WIPER AND WASHER SYSTEM

WIPER AND WASHER SYSTEM **RODIUS 2013.02**

3. MAJOR CHANGES IN WIPER & RAIN SENSOR SYSTEM

▶ Front view

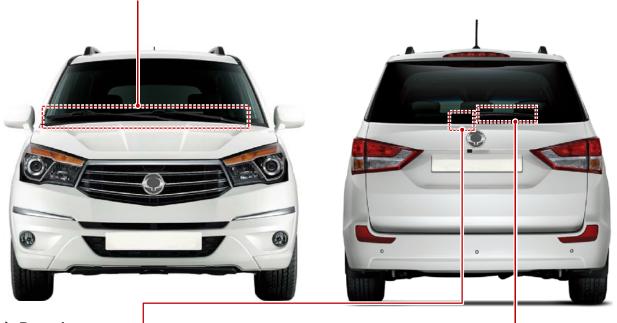
Before: Conventional type(driver: 600 mm, front passenger: 450 mm) After: Aero blade type(driver: 600 mm, front passenger: 450 mm)
